County of Loudoun  
Office of Transportation Services  
MEMORANDUM

**DATE:** October 10, 2006

**SUBJECT:** ZMAP 2006-0011, ZCPA 2006-0003—Stone Ridge Commercial  
First Referral

Figure 4  
Existing Lane Use and Traffic Control

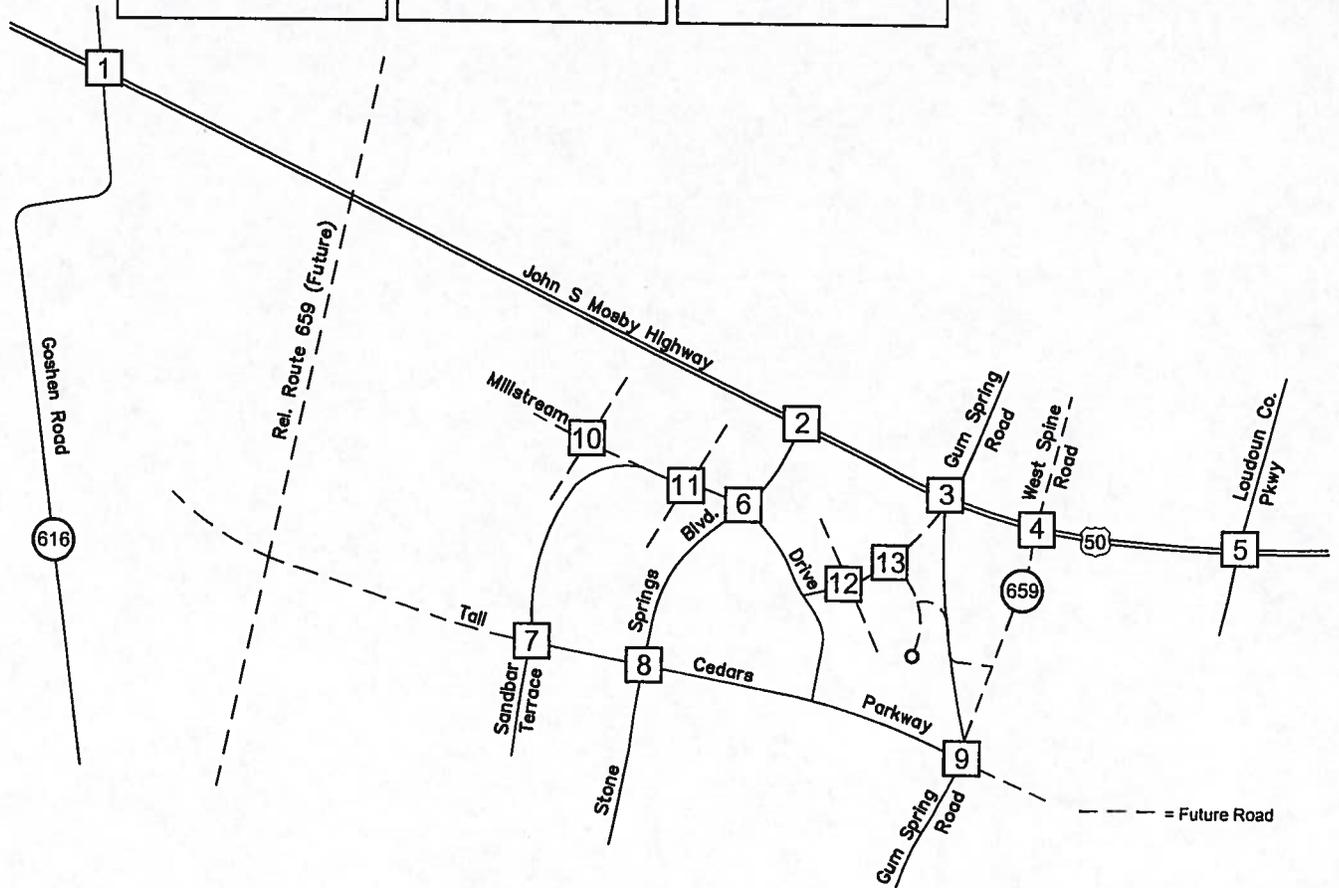
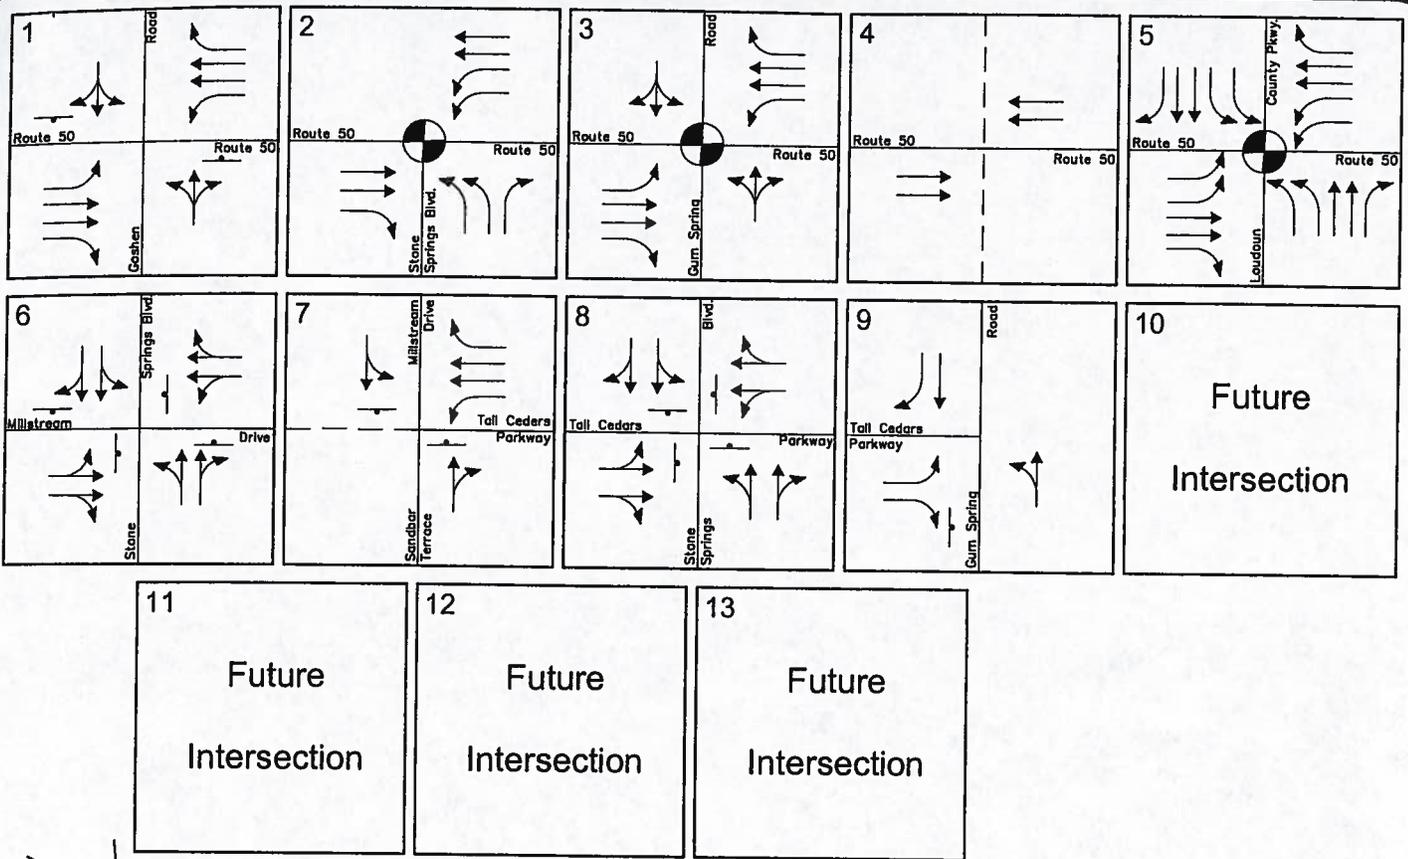
*Attachment 4* illustrates existing daily and peak hour traffic volumes and levels of service (LOS) in the vicinity of the subject site. *Attachment 5* shows existing lane use and traffic controls in the vicinity of the subject site. The study notes several unacceptable or failing peak hour LOS conditions for a number of locations included in the study area including the Route 50/Loudoun County Parkway intersection (signalized) as well as certain movements at the Gum Spring Road/Route 50 intersection (signalized). *Attachment 6* (Column 1) summarizes peak hour LOS at all intersections included in the study for existing the existing road network as well as for the currently approved and proposed road network (discussed further below).

Figure 6  
Approved Program Lane Use and Traffic Control

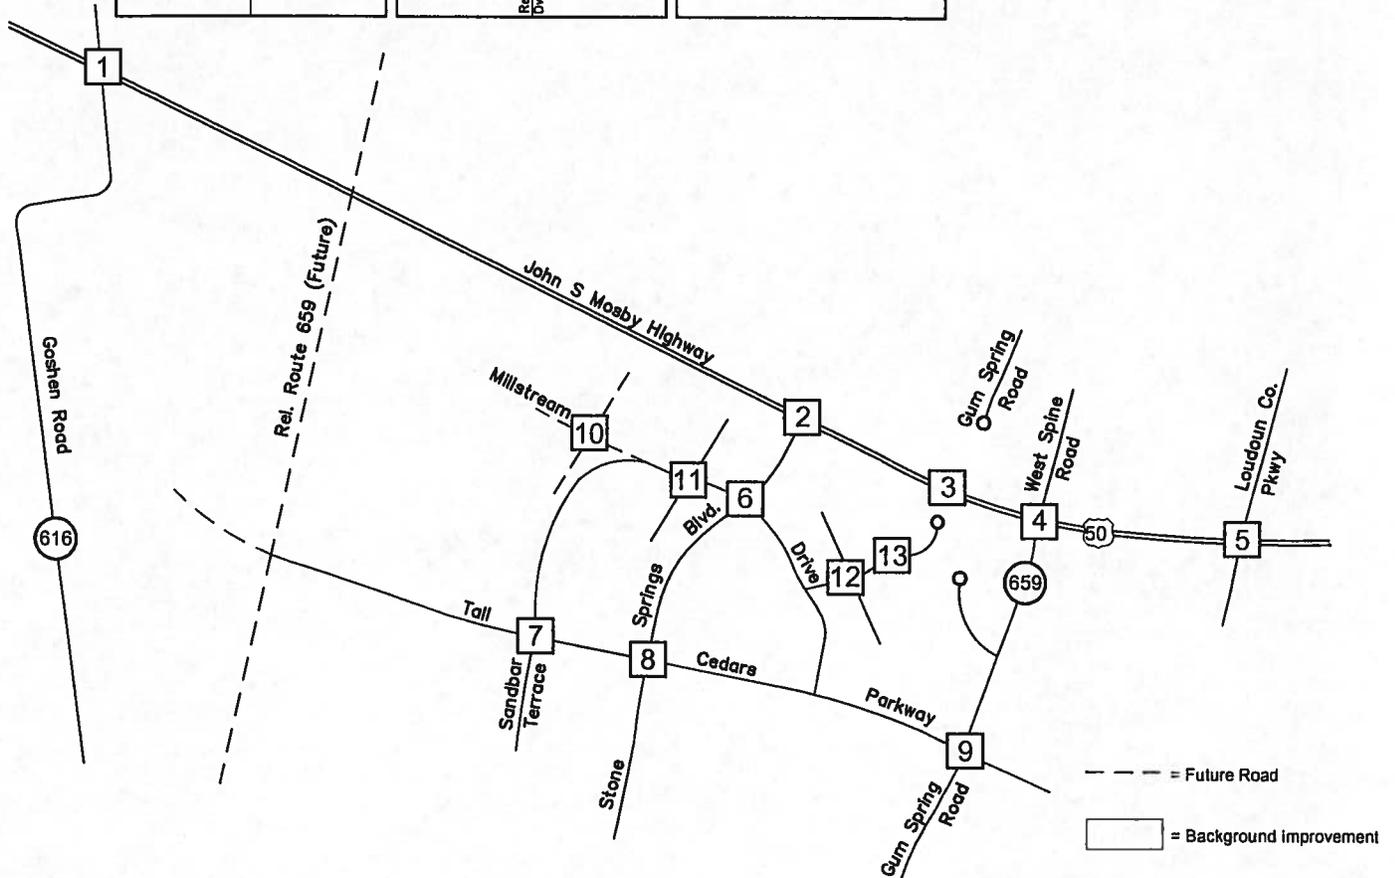
*Attachment 7* illustrates planned lane use and traffic controls in the vicinity of the subject site. This diagram reflects the road network as anticipated under the current Stone Ridge approvals (which are consistent with the adopted Revised CTP) and does not include road network changes proposed as part of the subject application (discussed further below). *Attachment 6* (Column 2) summarizes peak hour LOS at all intersections in the study area as anticipated under current approvals. *Attachment 8* depicts forecasted traffic (2010) on the currently-approved road network (i.e., Gum Spring Road is terminated and cul-de-sacs installed both north and south of Route 50).

**Figure 7**  
2010 Proposed Program Lane Use  
and Traffic Control

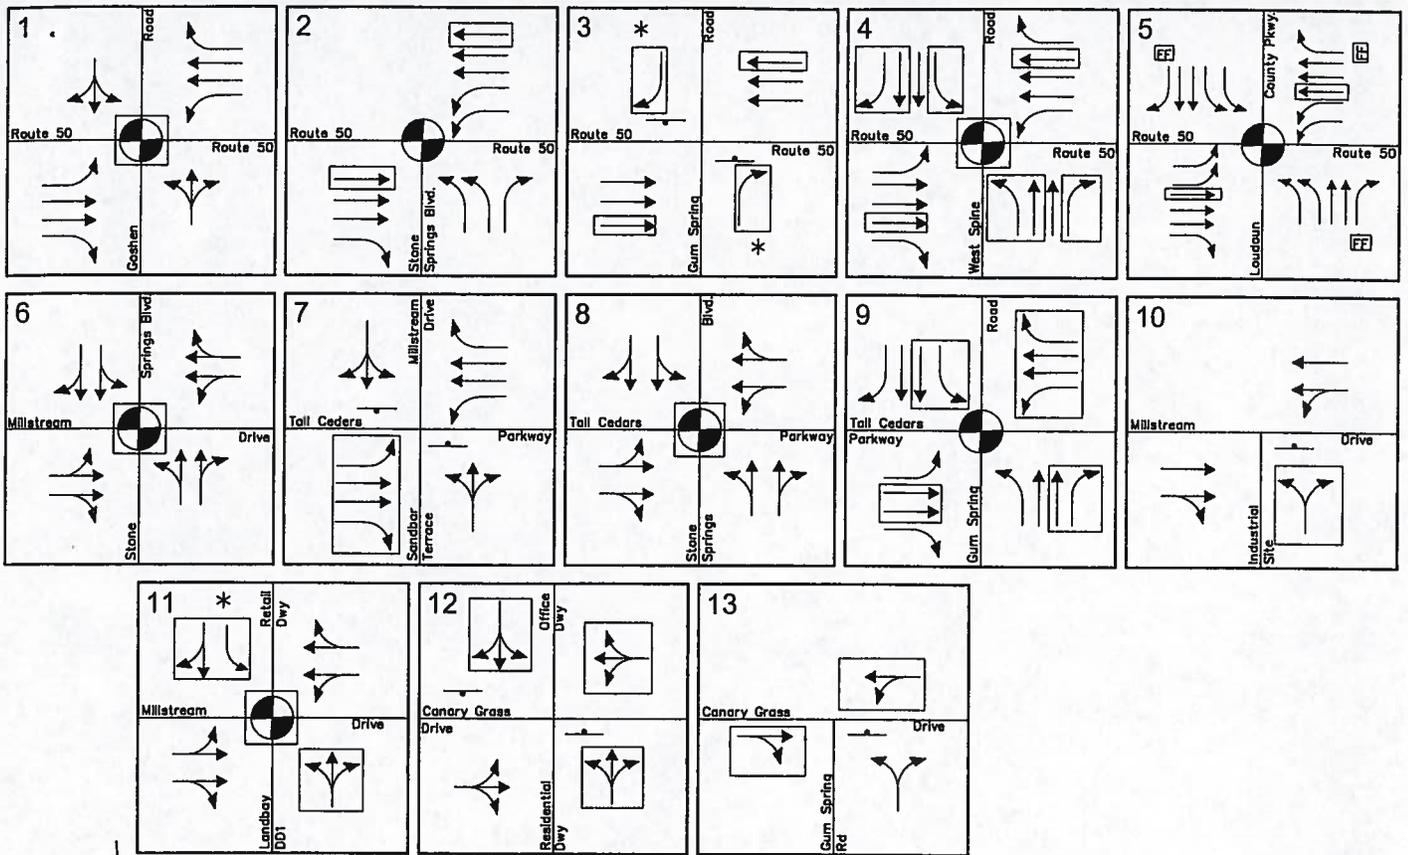
*Attachment 9* illustrates proposed lane use and traffic controls in the vicinity of the subject site. This diagram reflects modifications to the road network as proposed by the subject application, namely a right-in, right-out only lane configuration at Gum Spring Road and Route 50, and the re-alignment of Millstream Drive to remove its western segment connecting to Tall Cedars Parkway. *Attachment 6* (Column 3) summarizes peak hour LOS at all intersections in the study area as anticipated with the proposed development. *Attachment 10* depicts forecasted traffic (2010) on the proposed road network (i.e., existing Gum Spring Road realigned with Canary Grass Drive and maintains right-in, right-out only movements from eastbound Route 50). Please see the issues below for further discussion of the proposed realignment/reconfiguration of the existing Gum Spring Road/Route 50 intersection.
